April 27, 2012

Peach Bottom Atomic Power Station, Units 2 and 3  
Renewed Facility Operating License Nos. DPR-44 and DPR-56  
NRC Docket Nos. 50-277 and 50-278

Subject: License Amendment Request – Relocation of Pressure and Temperature Limit Curves to the Pressure and Temperature Limits Report

Figure 3.4.9-1 (page 1 of 1)

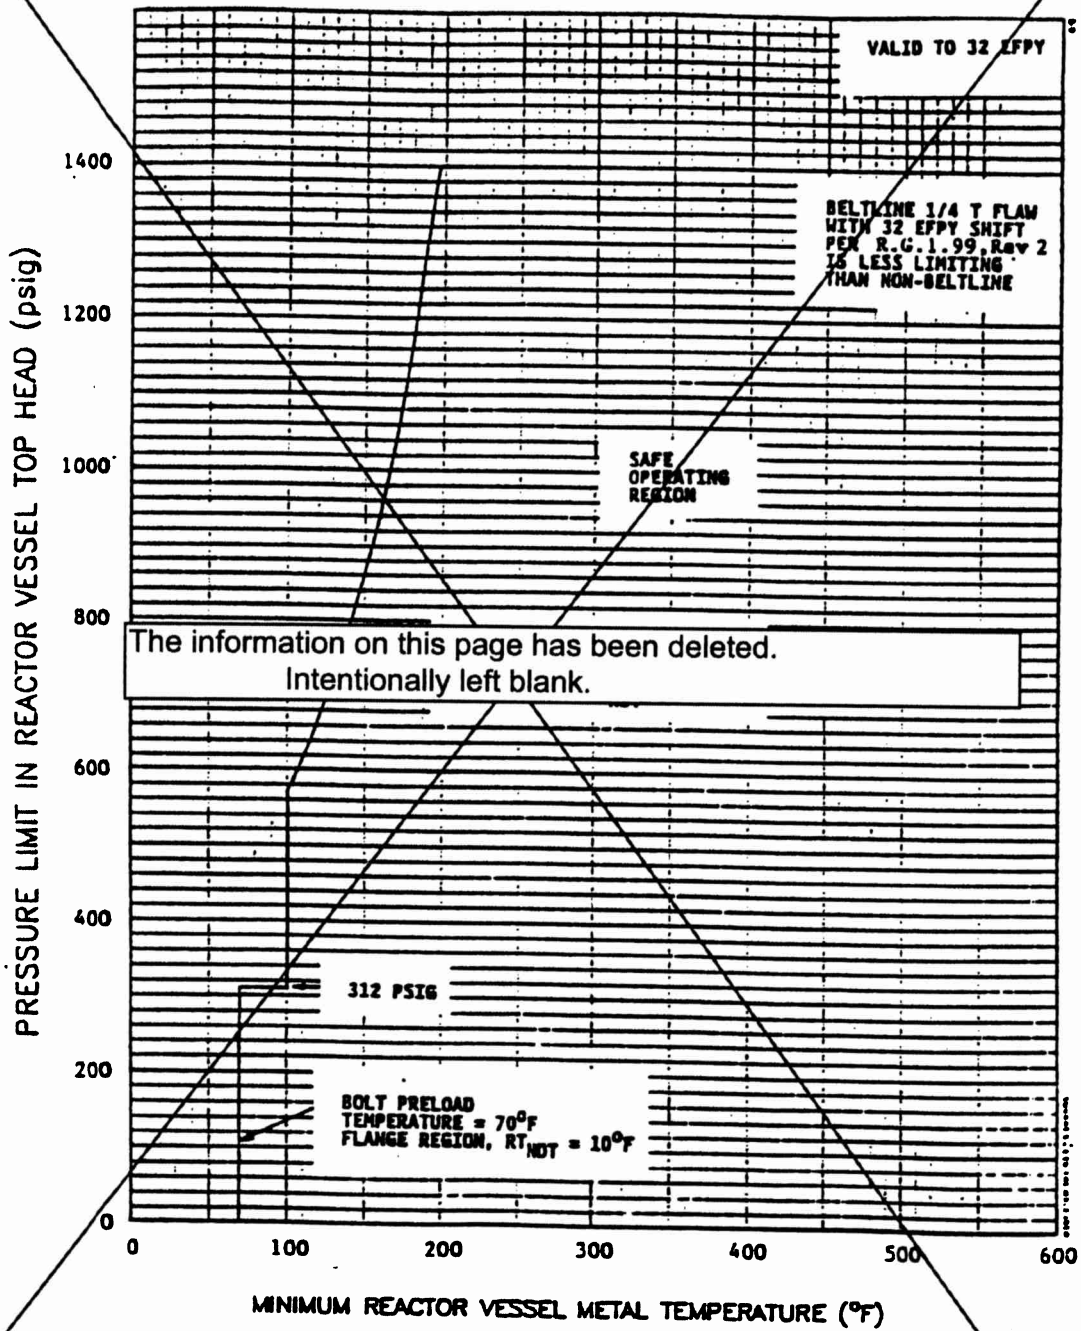
SURVEILLANCE	FREQUENCY
<p>SR 3.4.9.1 -----NOTE----- Only required to be performed during RCS heatup and cooldown operations and RCS inservice leak and hydrostatic testing. ----- Verify: a. RCS pressure and RCS temperature are <del>within the applicable limits specified in figures 3.4.9.1 and 3.4.9.2;</del> and b. RCS heatup and cooldown rates are <del>≤ 100°F in any 1-hour period.</del></p>	<p>In accordance with the Surveillance Frequency Control Program.</p>

Figure 3.4.9-3 (page 1 of 1)  
Temperature/Pressure Limits for Criticality

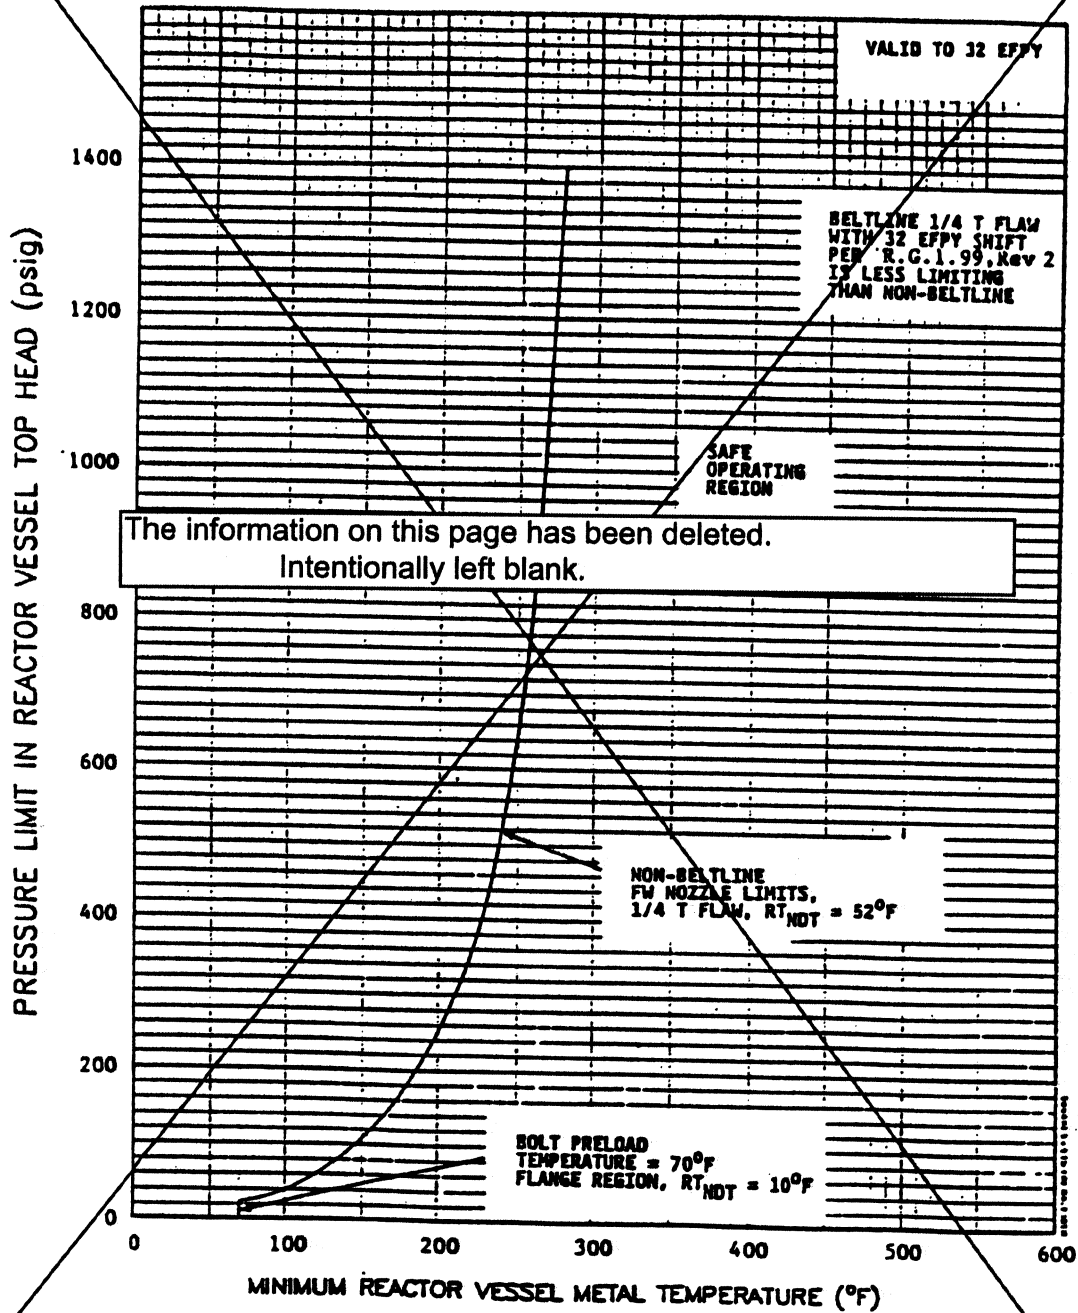
SURVEILLANCE	FREQUENCY
<p>SR 3.4.9.2 Verify RCS pressure and RCS temperature are within the criticality limits specified in <del>Figure 3.4.9-3.</del></p> <p style="text-align: center;">  </p>	<p>Once within 15 minutes prior to control rod withdrawal for the purpose of achieving criticality</p>
<p>SR 3.4.9.3 -----NOTE----- Only required to be met in MODES 1, 2, 3, and 4 during recirculation pump start. -----</p> <p>Verify the difference between the bottom head coolant temperature and the reactor pressure vessel (RPV) coolant temperature is <del>≤ 145°F.</del></p> <p style="text-align: center;">  </p>	<p>Once within 15 minutes prior to each startup of a recirculation pump</p>
<p>SR 3.4.9.4 -----NOTE----- Only required to be met in MODES 1, 2, 3, and 4 during recirculation pump start. -----</p> <p>Verify the difference between the reactor coolant temperature in the recirculation loop to be started and the RPV coolant temperature is <del>≤ 90°F.</del></p> <p style="text-align: center;">  </p>	<p>Once within 15 minutes prior to each startup of a recirculation pump</p>

Figure 3.4.9-1 (page 1 of 1)

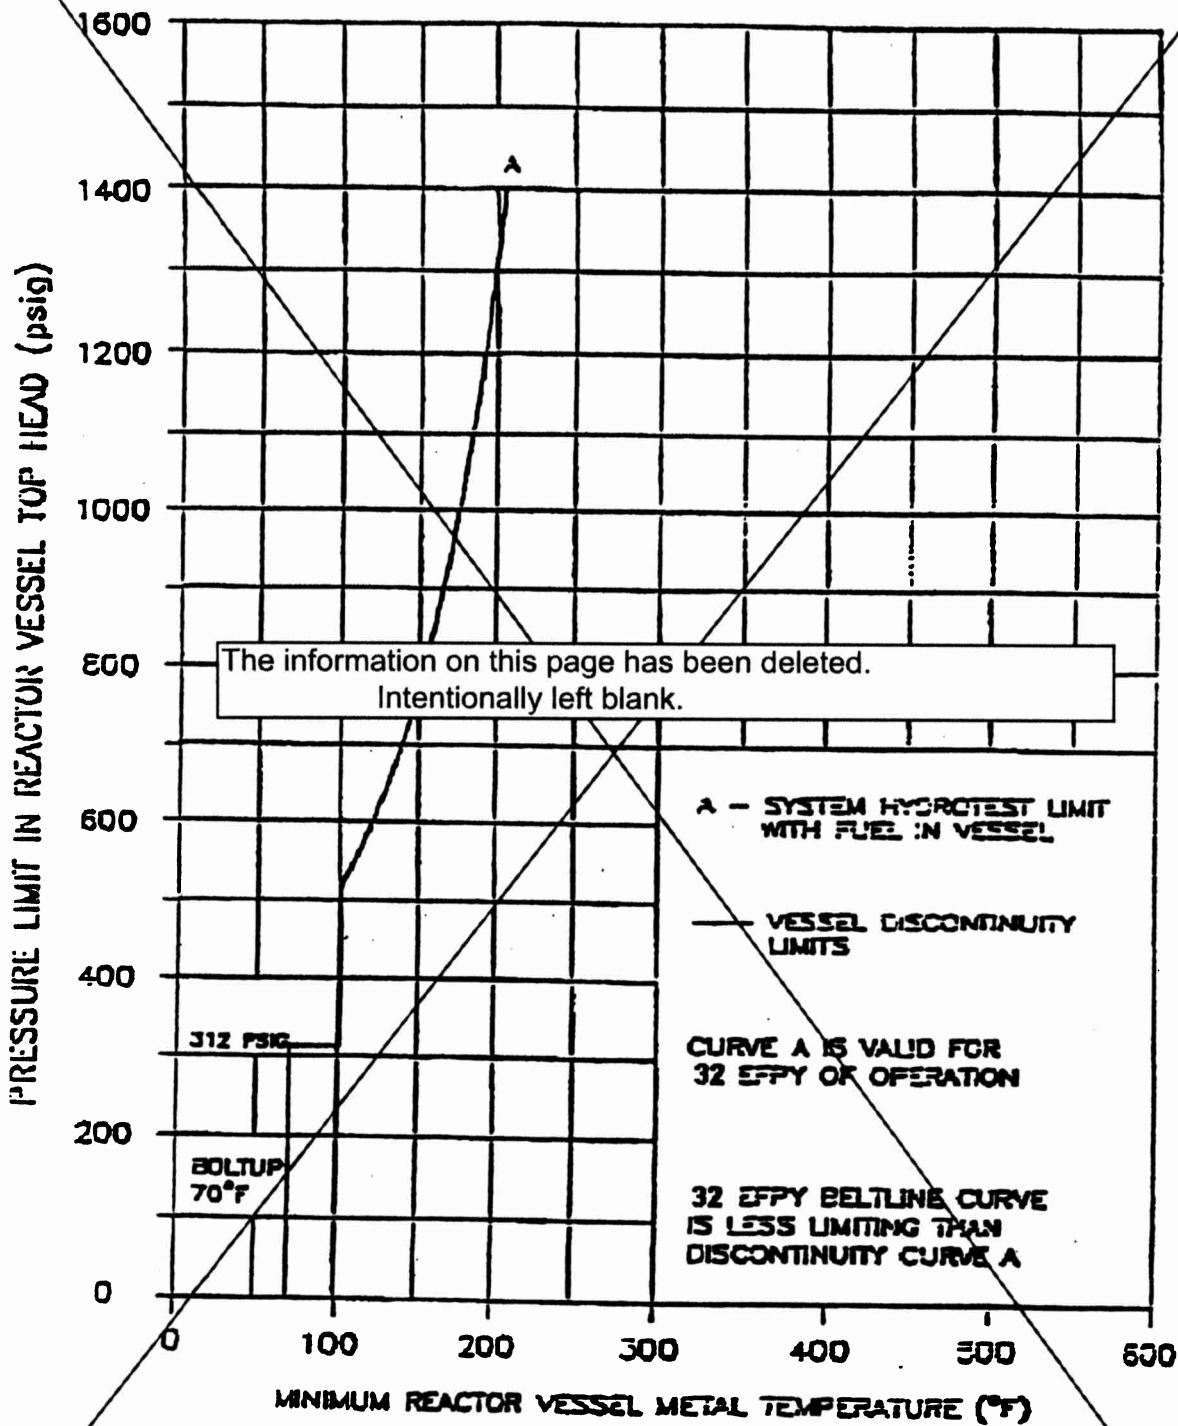
SURVEILLANCE	FREQUENCY
<p>SR 3.4.9.1 -----NOTE----- Only required to be performed during RCS heatup and cooldown operations and RCS inservice leak and hydrostatic testing. ----- Verify: a. RCS pressure and RCS temperature are <del>within the applicable limits specified in figures 3.4.9-1 and 3.4.9-2;</del> and b. RCS heatup and cooldown rates are <del>≤ 100°F in any 1-hour period.</del></p>	<p>In accordance with the Surveillance Frequency Control Program.</p>
